# Memo

Subject: **Hill Country Indoor PDD Amendment** – 2<sup>nd</sup> Round Technical Comments

# Memo

Subject: **Hill Country Indoor PDD Amendment** – 1<sup>st</sup> Round Technical Comments

### Ord 142-201 Exhibit B1

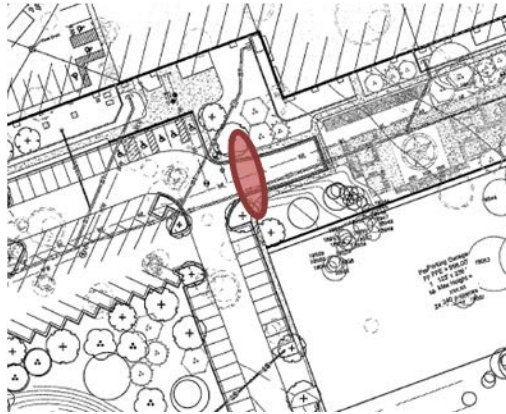
- iii. **Pedestrian Connectivity Between Garage and Primary Building:** To improve safety, add a crosswalk in the **location depicted below**. Confirm it will be ADA compliant or, if it will not be, highlight the additional, proposed, ADA compliant connection.
